Groundwater Transfer Review Summary Form

Transfer/PA # T- 14482

Ground Water Review Form:

Application: T-14482

T-14482 - POA MAP

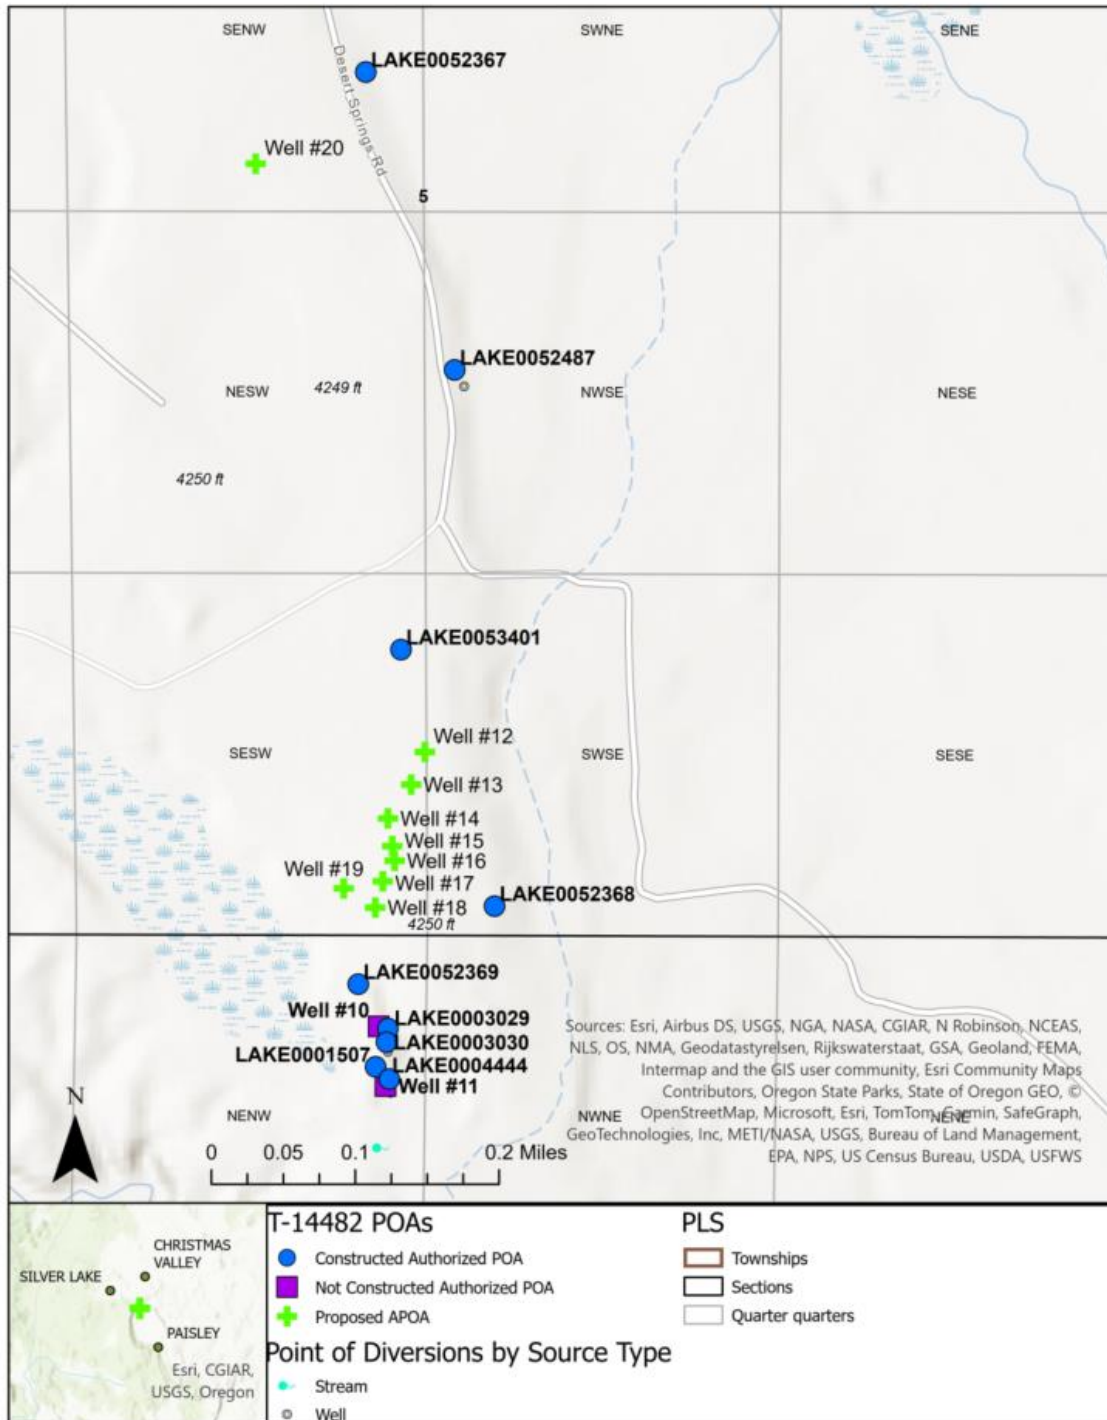
5. a) Will this proposed change, at its maximum allowed rate of use, likely result in an increase in interference with **another ground water right**?
☒ Yes ☐ No Comments: The location of APOA WELL #20 will move groundwater use ~300 feet closer to LAKE 1503, an authorized POA for Certificate 90178, than currently authorized POA WELL #5 (LAKE 52367). This reduction in intervening distance is likely to result in an increase in interference with existing well LAKE 1503.

6. a) Will this proposed change, at its maximum allowed rate of use, likely result in an increase in interference with **another surface water source**?
☒ Yes ☐ No Comments: The location of APOA Well #20 will move groundwater use ~100 feet closer to Ana Springs/Ana Reservoir when compared to authorized WELL #5 (LAKE 52367).

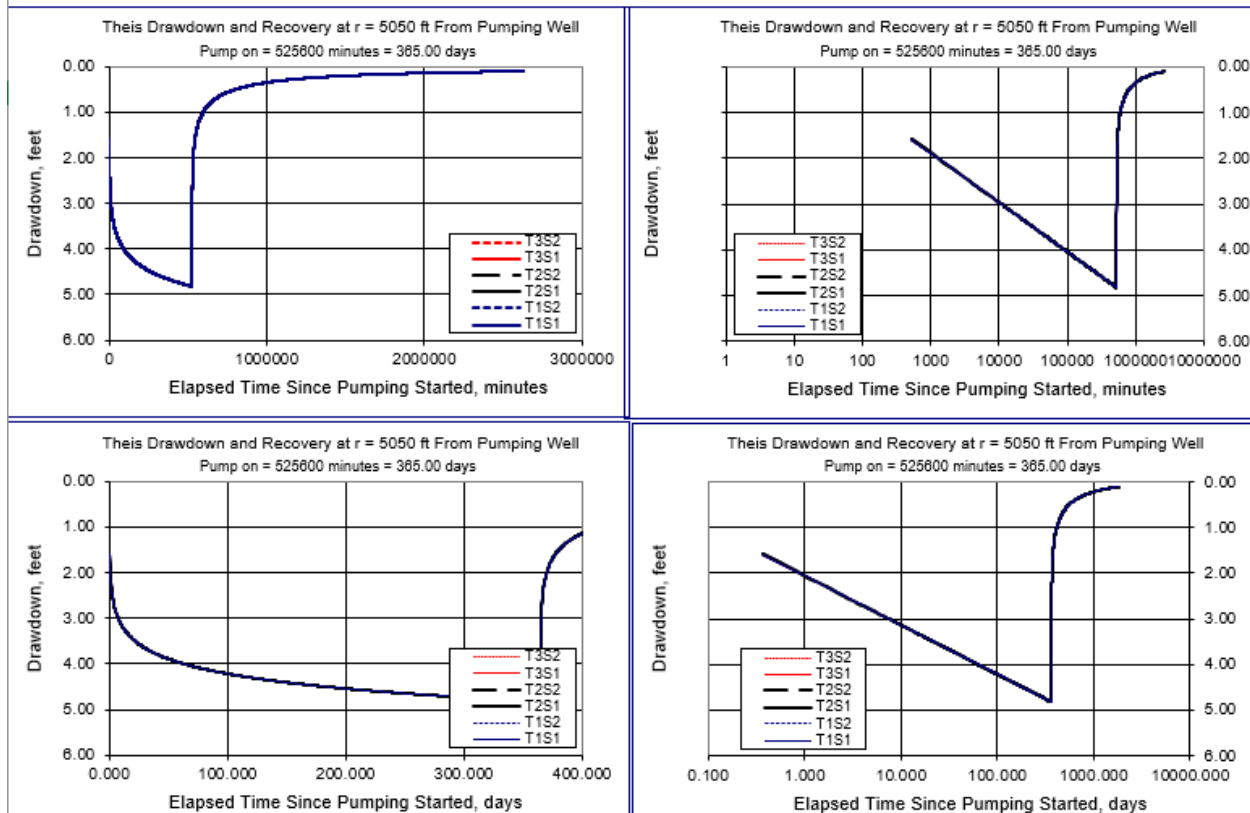
- b) If yes, would this proposed change, at its maximum allowed rate of use, likely result in another groundwater right not receiving the water to which it is legally entitled?
☐ Yes ☒ No If yes, explain: The potential increase in drawdown was calculated using the Theis equation (see attachments). The values used for the calculation are conservative and appropriate until better values become available. Storage coefficient (0.00029) and transmissivity values (260,677 ft²/day) used for the calculation were sourced from Brown (1957). At the maximum allowed pumping rate of 17.8 cfs the increase in drawdown is estimated to be <1 foot compared to what is already occurring under the currently authorized POA, which is unlikely to result in another groundwater right not receiving the water to which it is legally entitled.
